## ST. TAMMANY PARISH

**Addendum No.:** 1

**Bid#:** 21-4-2

**Project Name:** Soult Street Road Improvements

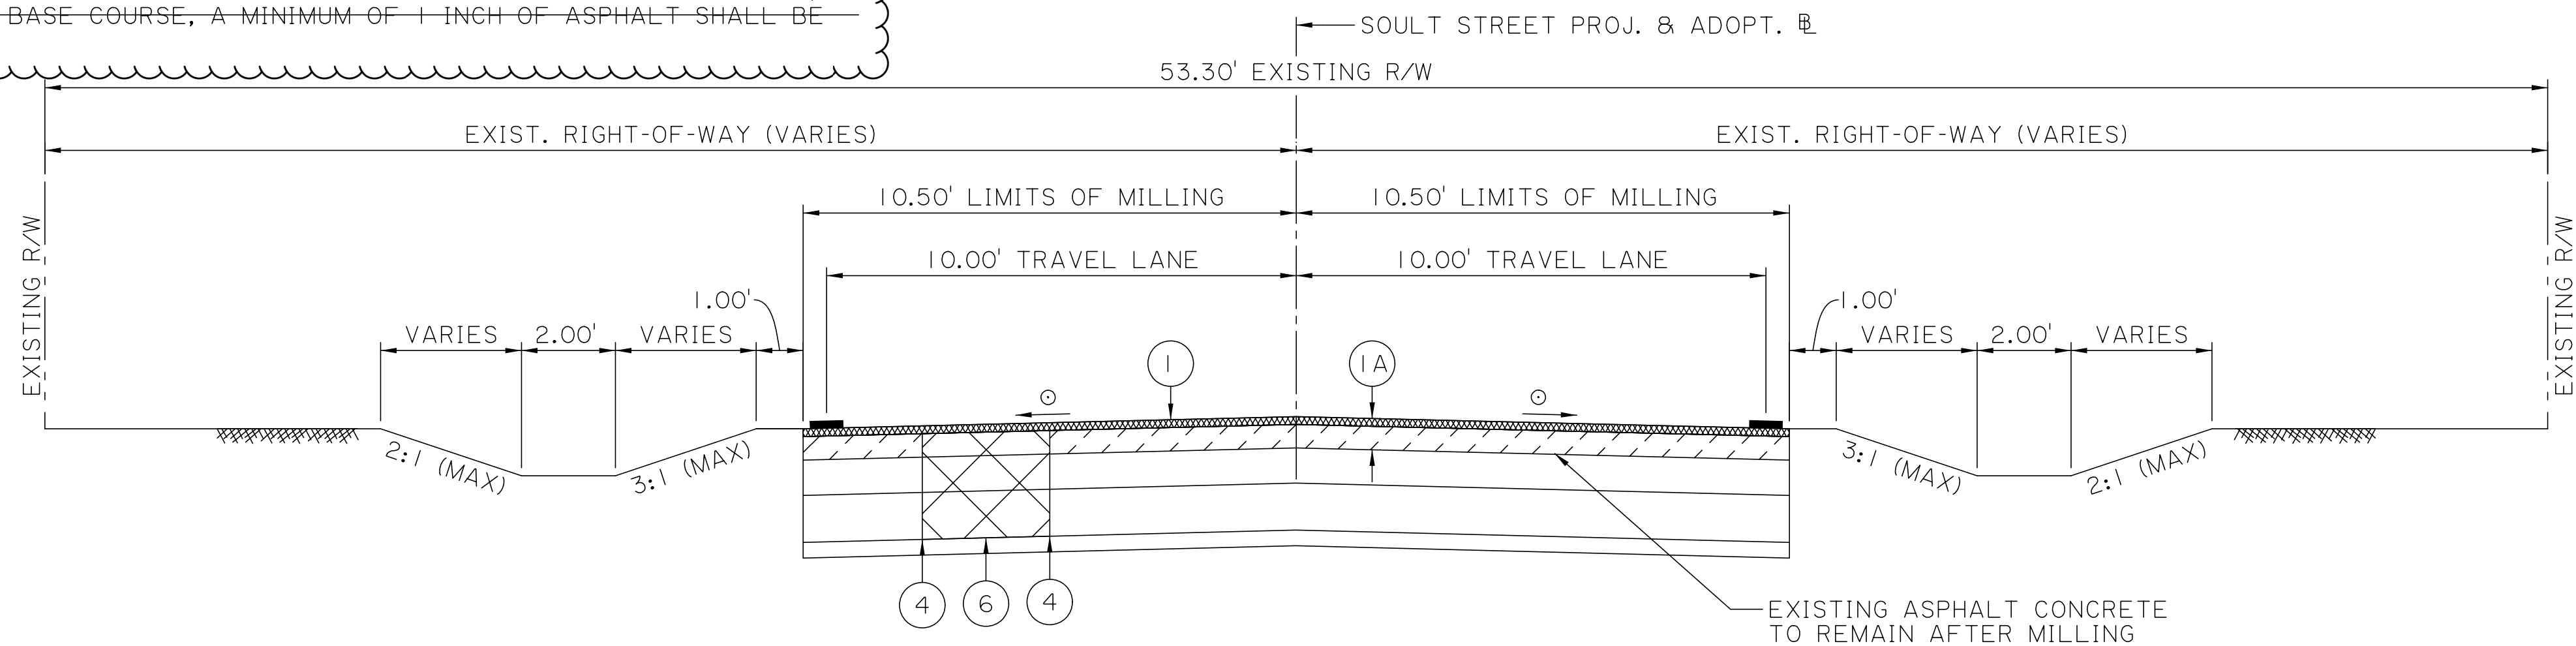
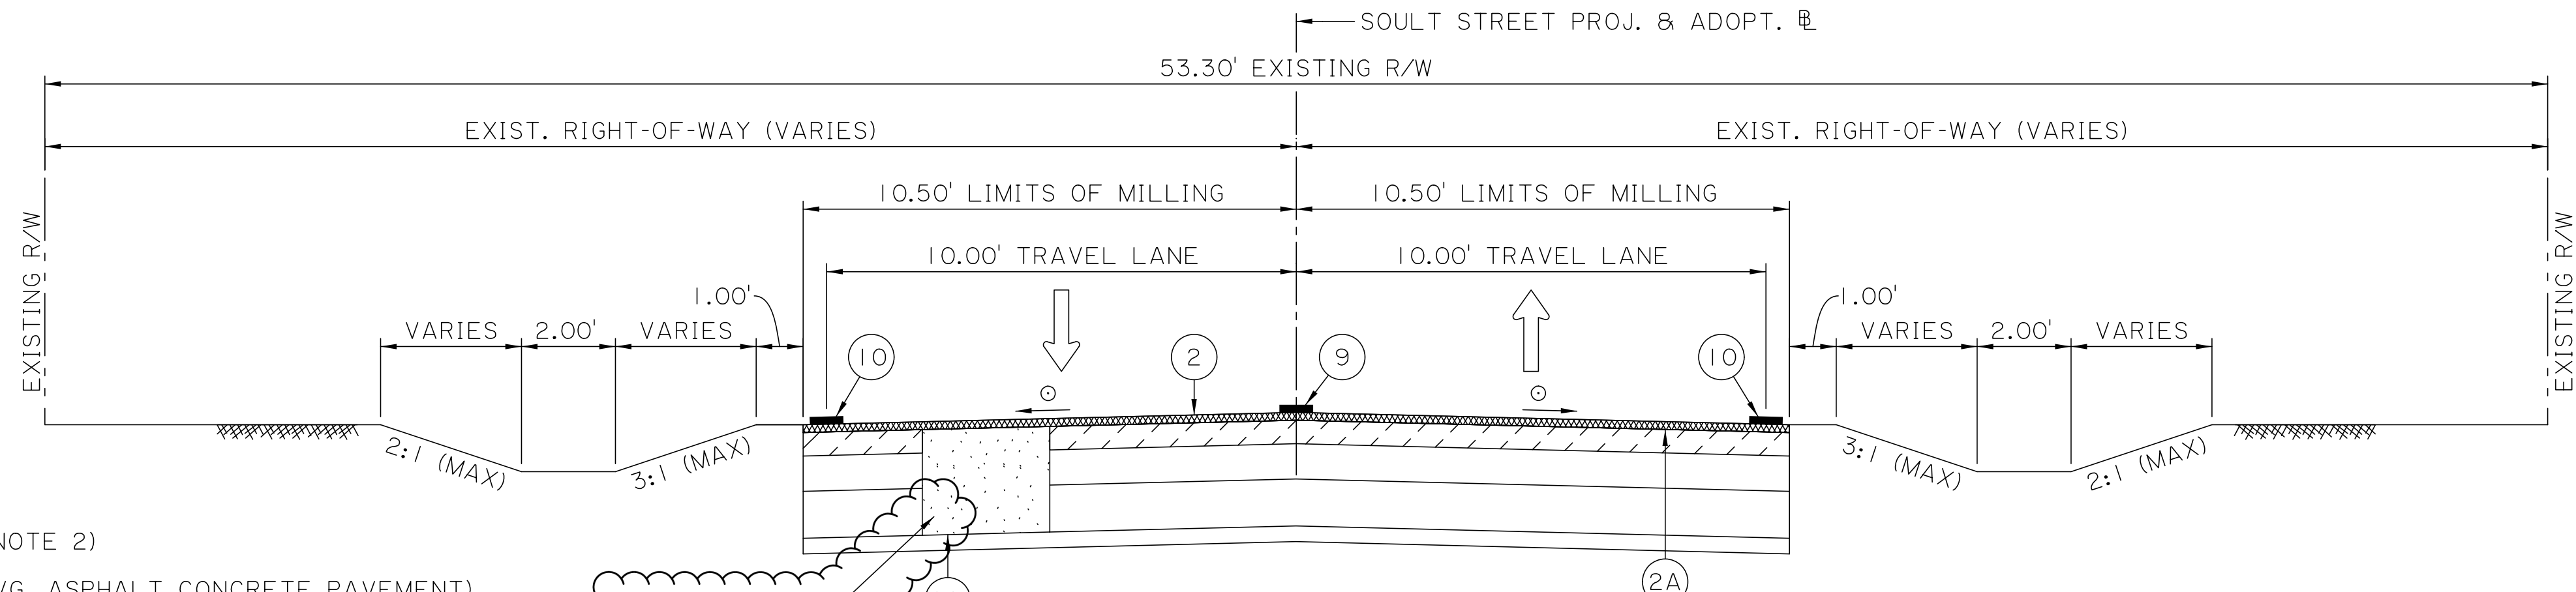
**Question 1:** PLAN SHEET 2B TYPICAL DISCRIPTION 11 refers to a 12" THICK AVERAGE ASPHALT CONCRETE PATCHING (LEVEL 2); however, there is a note "SEE NOTE 4" referencing that section in the typical drawing. The note states CONTRACTOR HAS THE OPTION TO USE FULL DEPTH ASPHALT PATCHES... Etc. My question is isn't 12" asphalt patching REQUIRED? Is there a CLASS II BASE COURSE REPAIR OPTION that can be used in place of the ASPHALT PATCHING indicated in description 11?

**Question 2.** PLAN SHEET 2B - CONCERNING ASPHALT PATCHING – (LEVEL 2) is in description 11. Was “LEVEL 2” a typo? Or is the intent to require the contractor to patch with LEVEL 2?

**Question 10.** SEE NOTE below. Plan does not state what asphalt mix design will be allowed in the substitute. Please let us know what mix design we are to plan to use.

**Answer 1.** No, class II base course repairs are not allowed for patching locations. Asphalt concrete is required for roadway patching.

For widened roadway sections and full reconstruction areas, class II base course is required; however, the Contractor has the option to use full depth asphalt concrete in lieu of the class II base course with written approval from St. Tammany Parish Department of Public Works. The asphalt concrete to class II base course substitution shall be achieved with a 1:2 ratio (i.e. for every 2 inches of class II base, a minimum of 1 inch of asphalt shall be substituted).

**Answer 2.** “LEVEL 2” requirement is shown in error on Sheet Number 2B. The contractor shall use Level 1F for asphalt wearing course and Level 1 for the 12” asphalt pavement patching. Sheet Number 2B has been revised and is included with this Addendum.

**Answer 10.** The required asphalt mix for base course is Level 1.

SHEET NUMBER	2D	ST. TAMMANY	000-52	ENI18000011
DESIGNED	CHECKED	CEH	RUB	DESIGNED
Detailed	Checked	BBS	CRH	Detailed
4 OF 6			REVISION OR CHANGE ORDER DESCRIPTION	
NO. DATE				
BY				
TYPICAL SECTIONS				
SOULT ST. ROAD IMPROVEMENTS

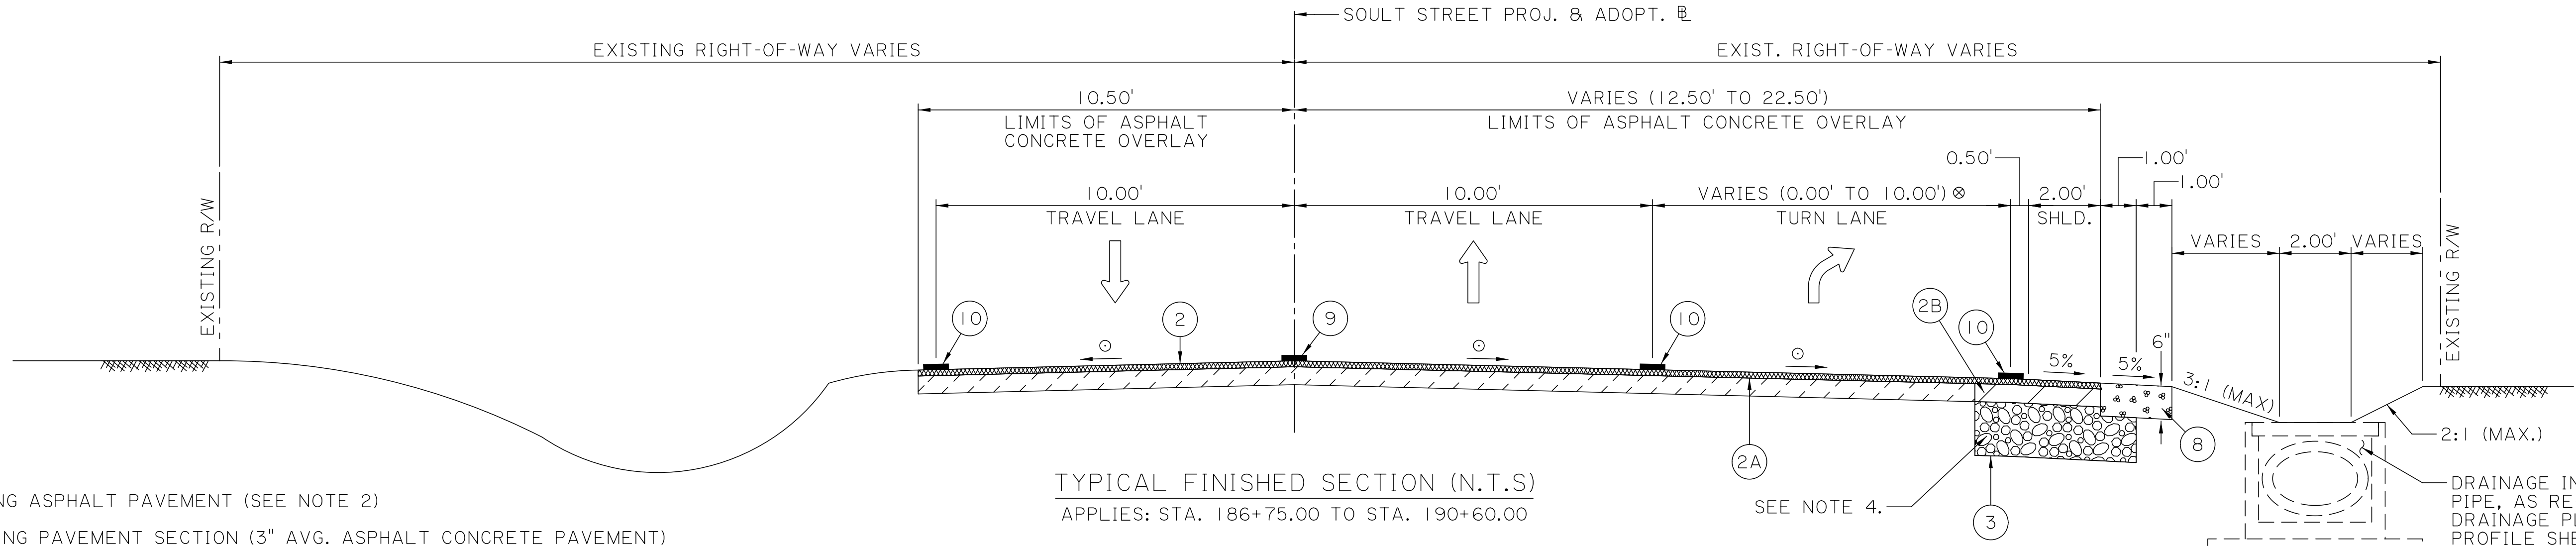
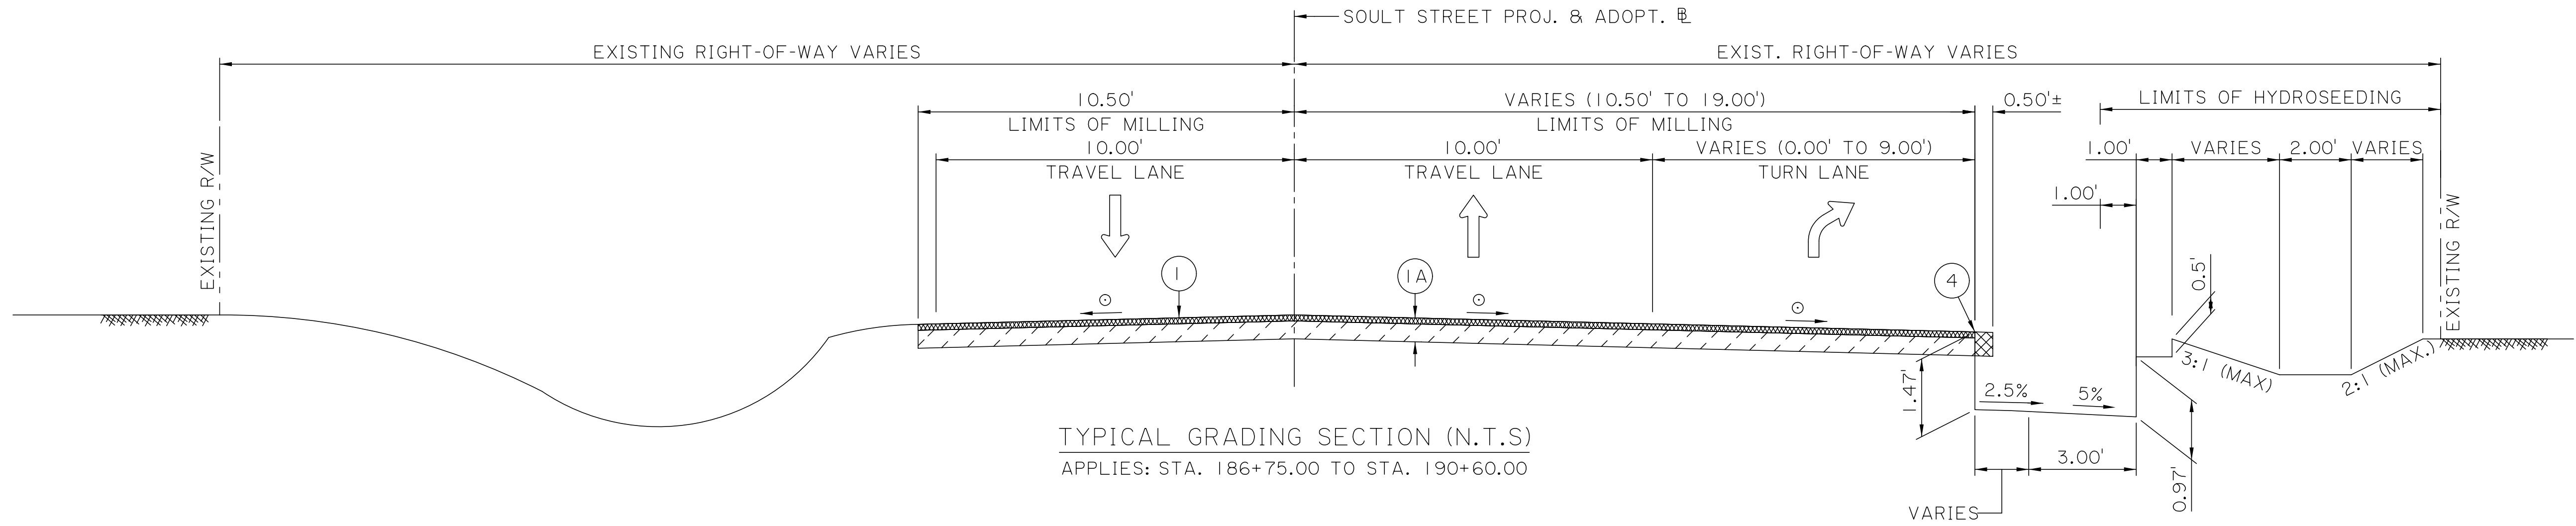
**Question 6.** Please provide sheet 2D for the Typical for Station 186+75 to 190+60.

**Answer 6.** Sheet Number 2D is added with this Addendum.
